Consultants Final Lot Grading Certification Letter

Re: Municipal Address: 1358 Harrington Street
Lot or Block No.: Lot 66
Registered Plan No.: 2021-0383
Certification of building and final lot grading
Bellaire Properties Inc.

1358 HARRINGTON STREET
LOT 66, PLAN 51M-1088
PHASE 2, STAGE
BELLAIRE PROPERTIES INC.
PARCEL P1 - LEFROY
TOWN OF INNISFIL

A-1

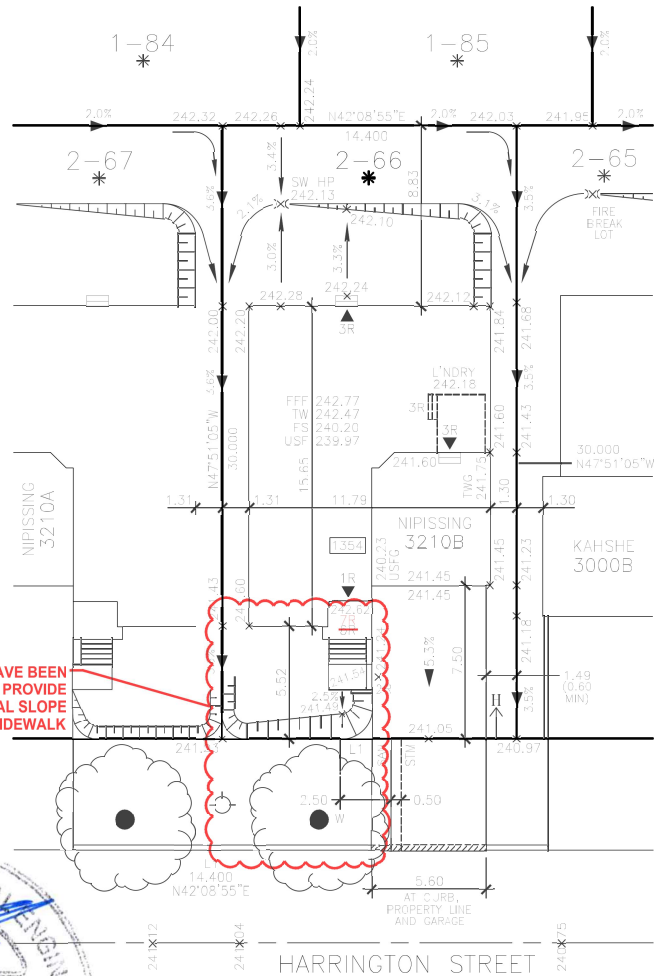
1. The lot grading and building elevations on the above referenced lot are:
 - ☐ In conformity with the approved grading and site plans
 - ☒ Not in conformity with the approved plan, but have been constructed in accordance to sound engineering principles and vary from the approved plan as shown on the attached "as-built" plan, signed and stamped by the undersigned, subject to approval by the Town of Innisfil.
2. The water service "curb-stop" is located in the grassed portion of the front yard, is accessible, and is flush with finished grade.

APPEARS TO HAVE BEEN CONSTRUCTED TO PROVIDE A MORE GRADUAL SLOPE FROM HOUSE TO SIDEWALK
